Great White Kaolin Project

Mining Proposal and Miscellaneous Purposes Licence Management Plans

RESPONSE DOCUMENT

July 2021

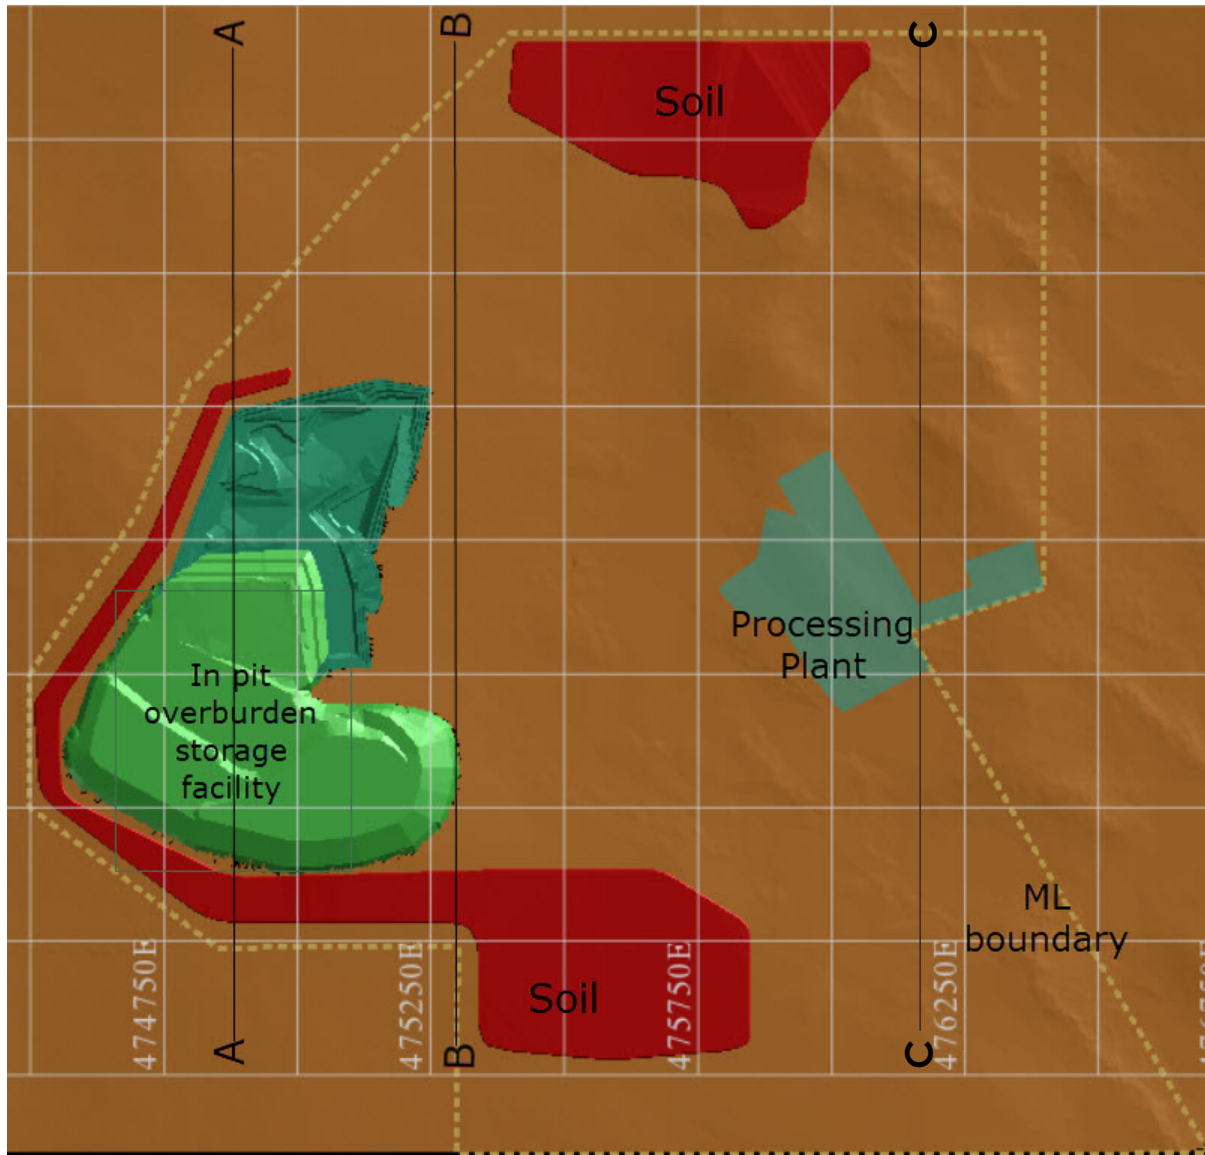
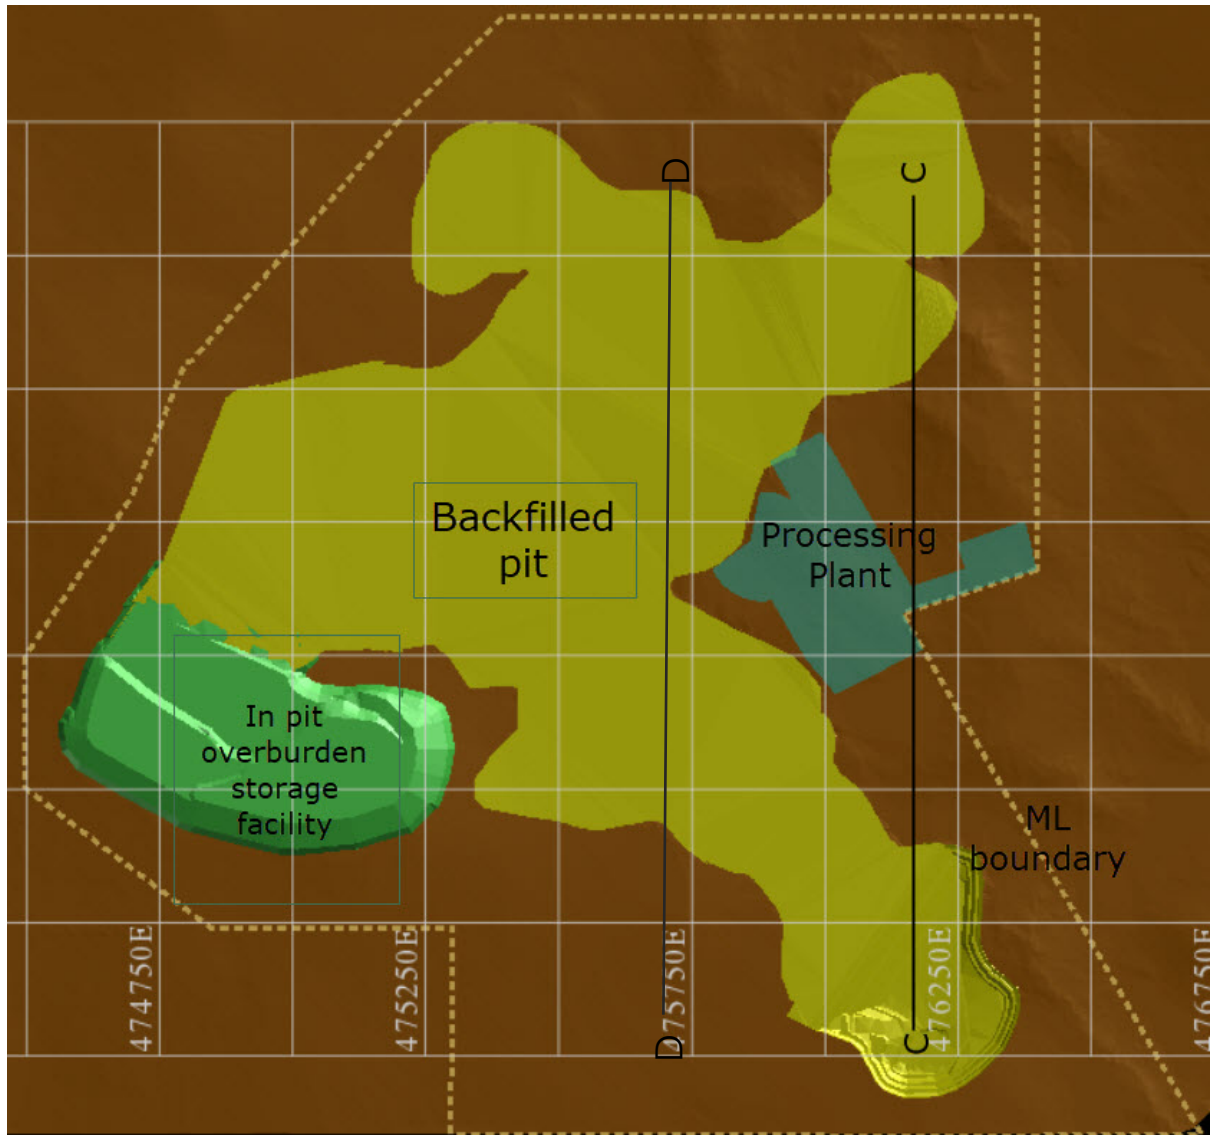
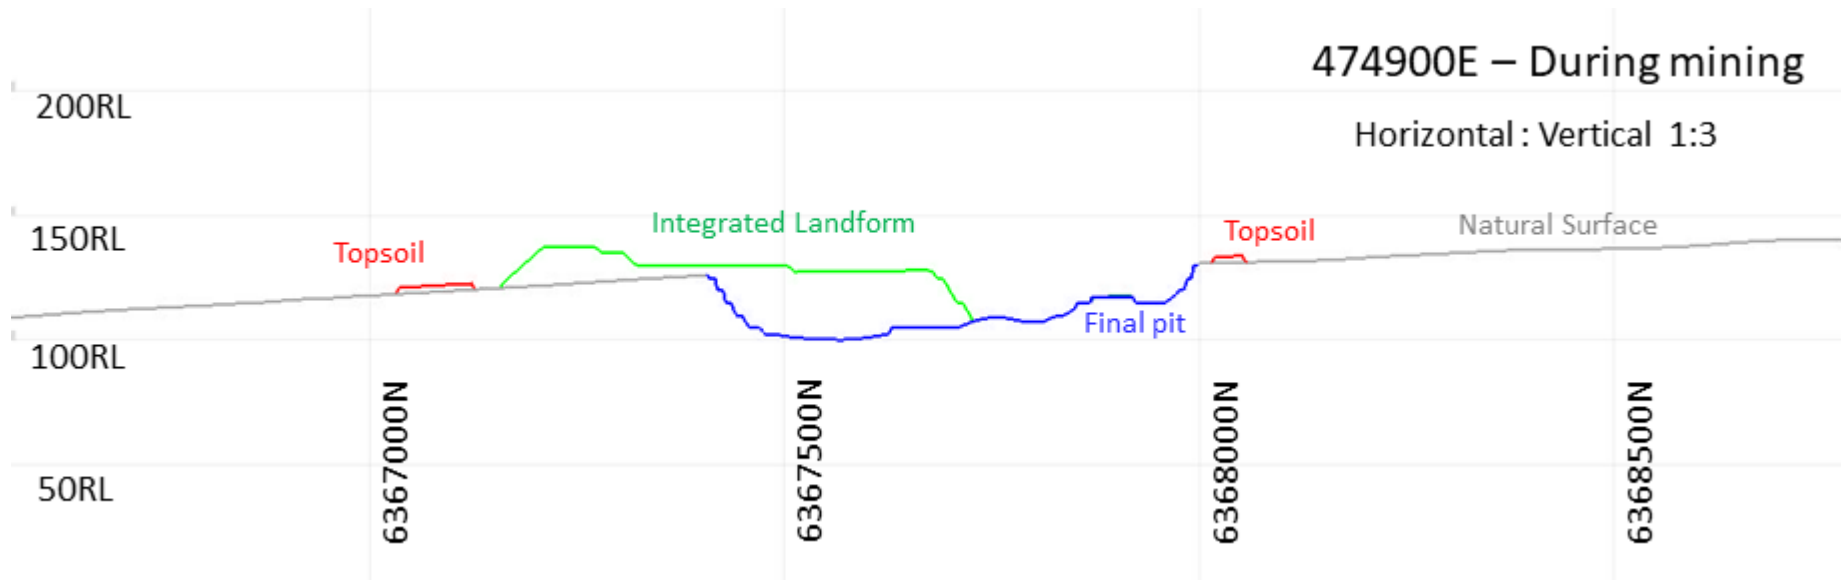
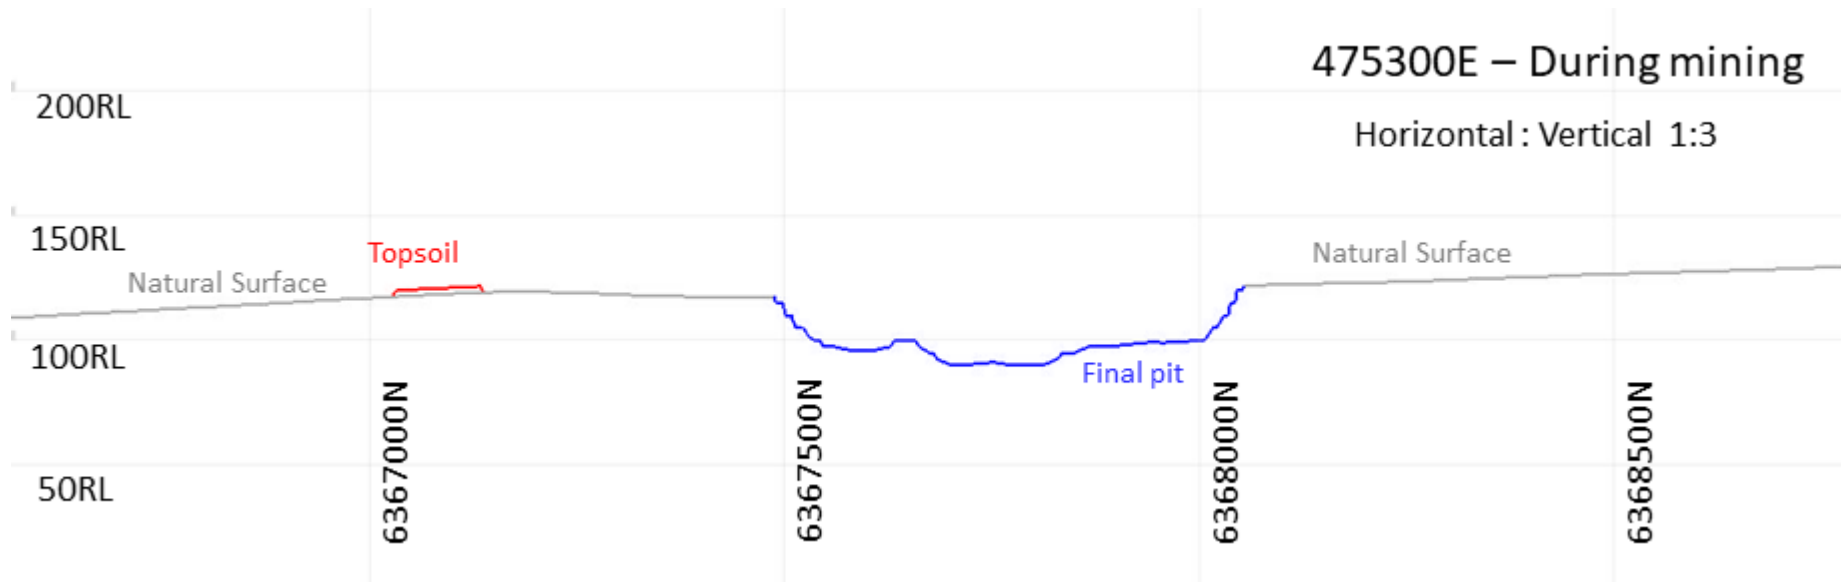
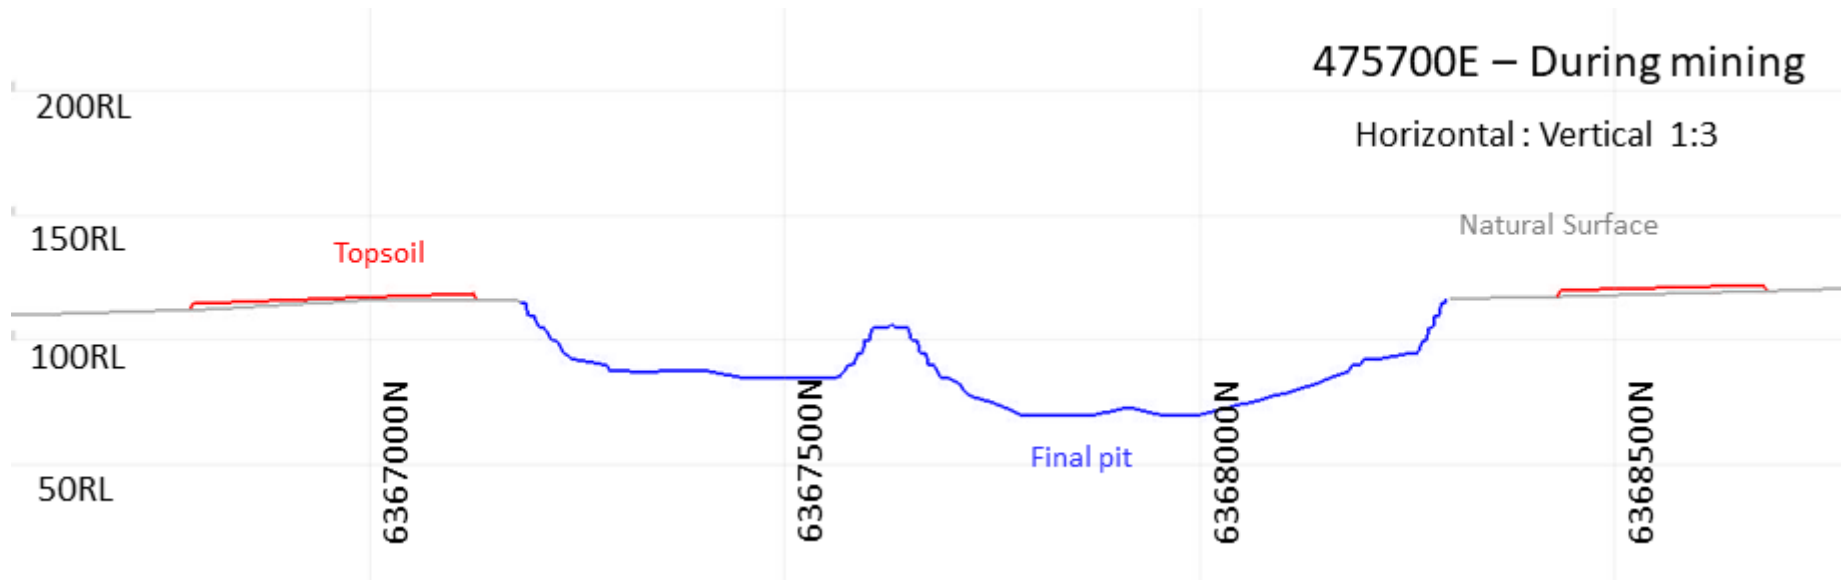
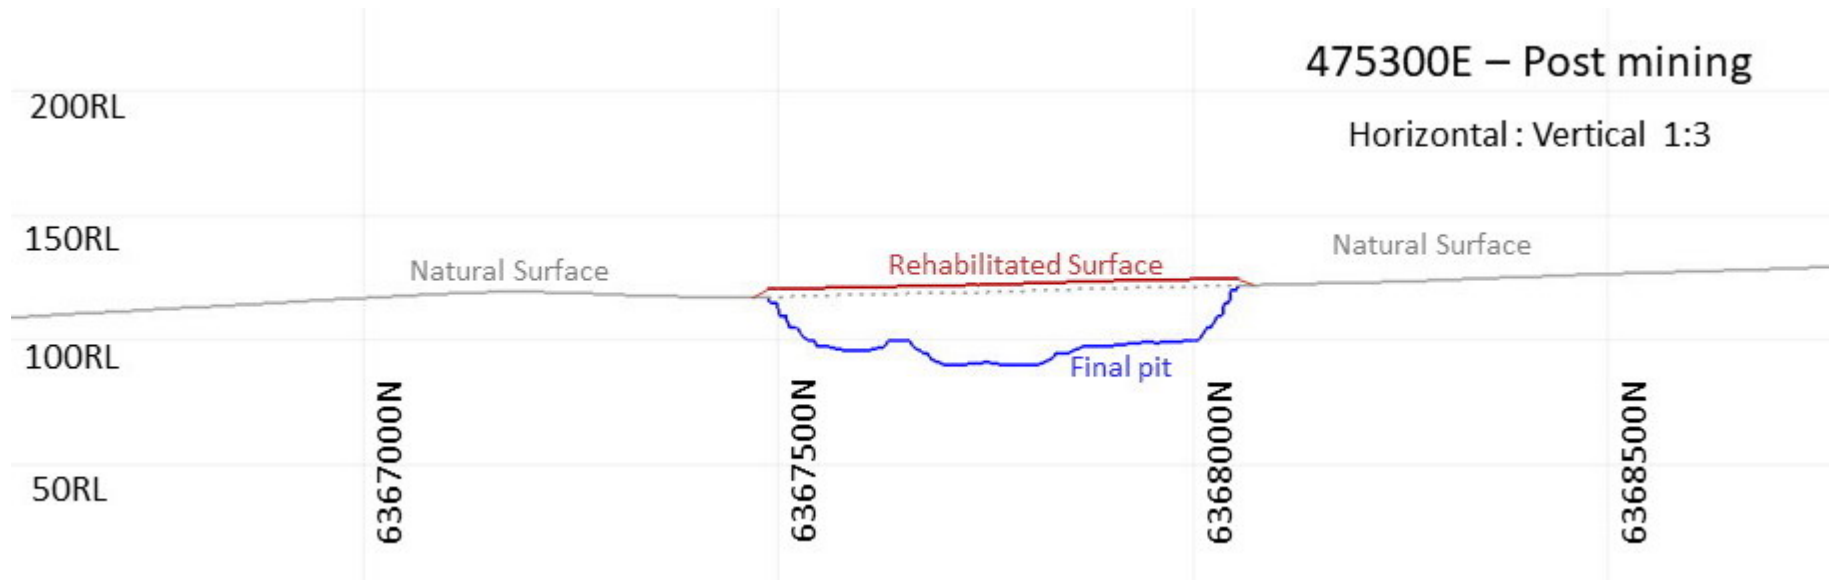
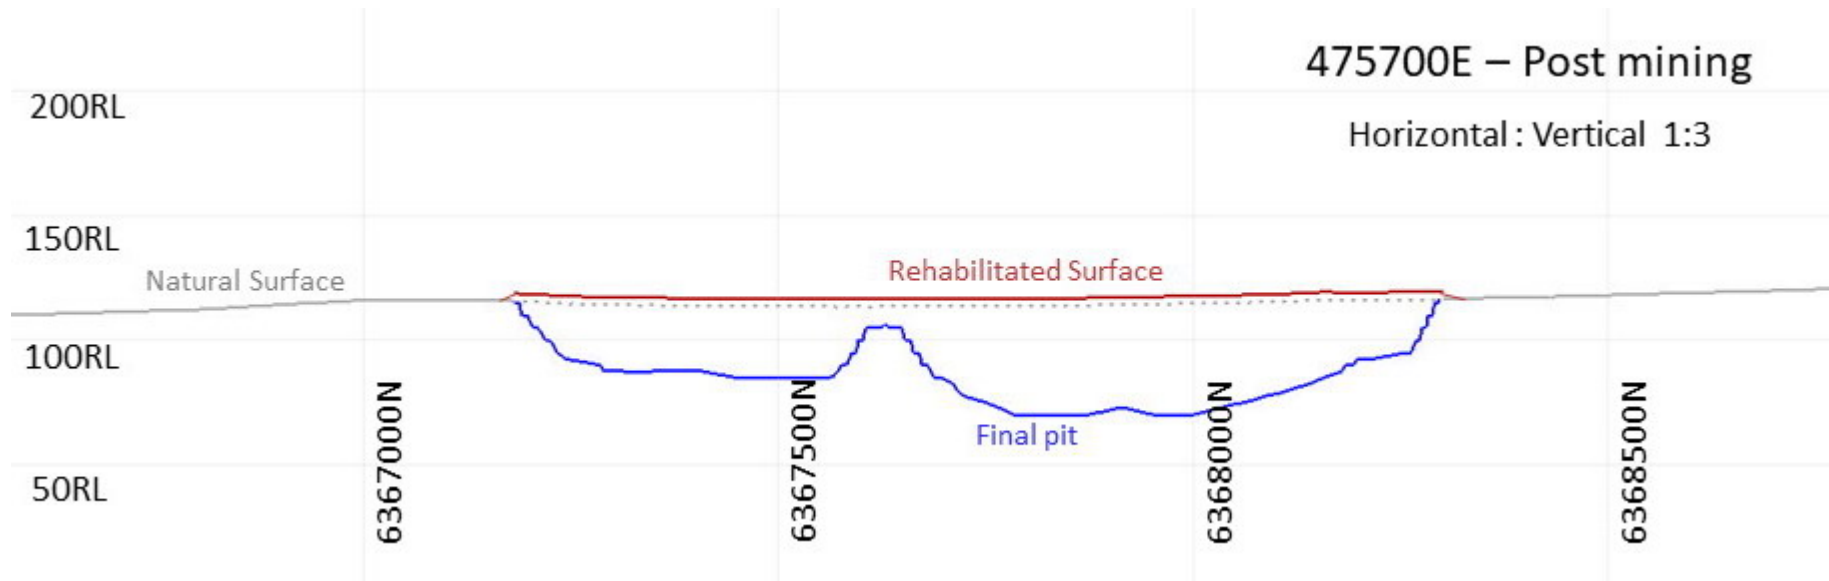
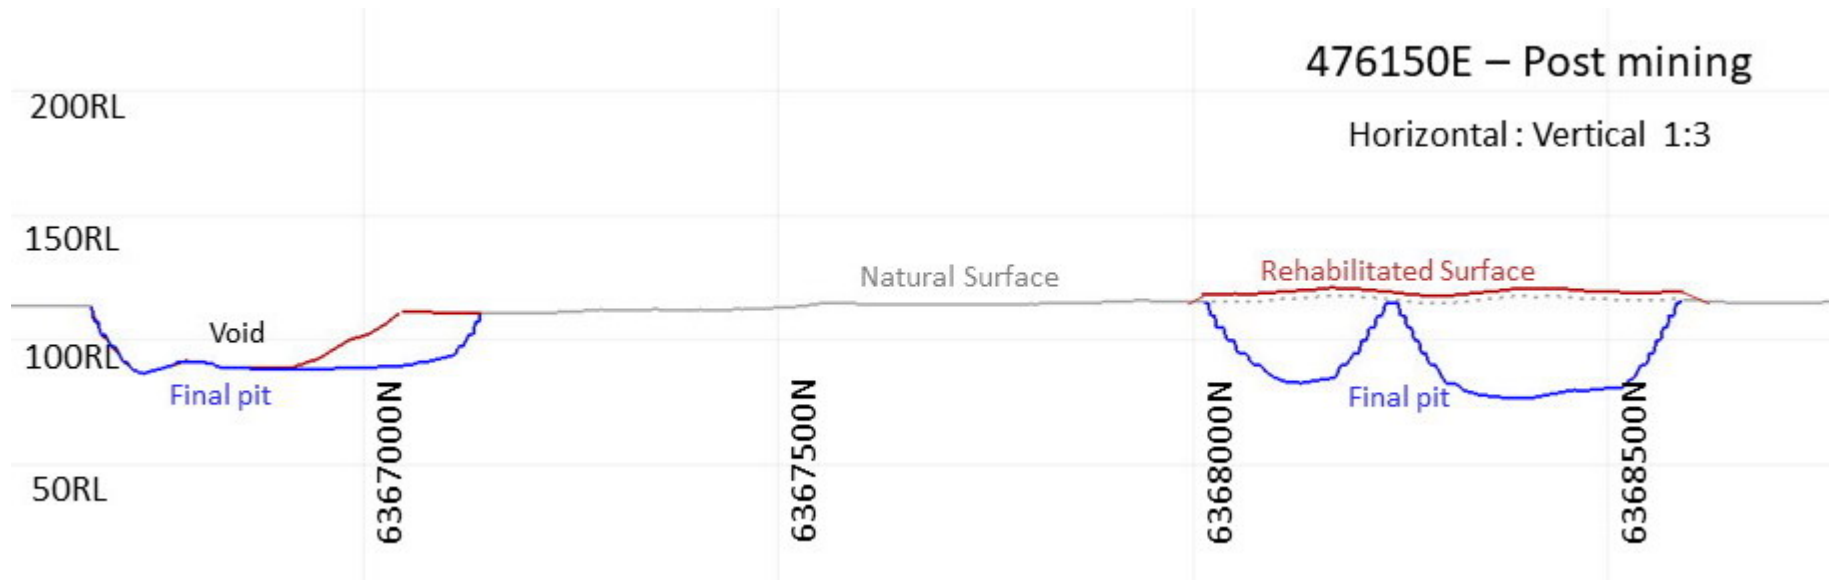
48. Carey Bros Family Trust	Section 3.9.1	Chapter 3 Description of Proposed Development	Rehabilitation and Closure	48.1 What are the dimensions (length, width and depth) of the mine void post closure? It is presented in Fig 3-27 and 3-28 but no values are provided. What is the final loss of farming land post mine?	48.1 The final mine void will be approximately 300 metres x 400 metres as per Figure 3-27 in the MP. The pit will be backfilled to form a safe and stable landform with final depth to be determined in PEPR. Post closure land uses will include both grazing and native vegetation. Updated site layout graphics are included in Appendix D.

50. Carey Bros Family Trust	Section 3.9.1	Chapter 3 Description of Proposed Development	Rehabilitation and Closure	50.1 The B line in 3-27 doesn't quite match up with what is presented in the cross section of 3-28.	50.1 The cross section in MP Figure 3-27 and 3-28 is conceptual. A more detailed cross section has been provided in Appendix D.
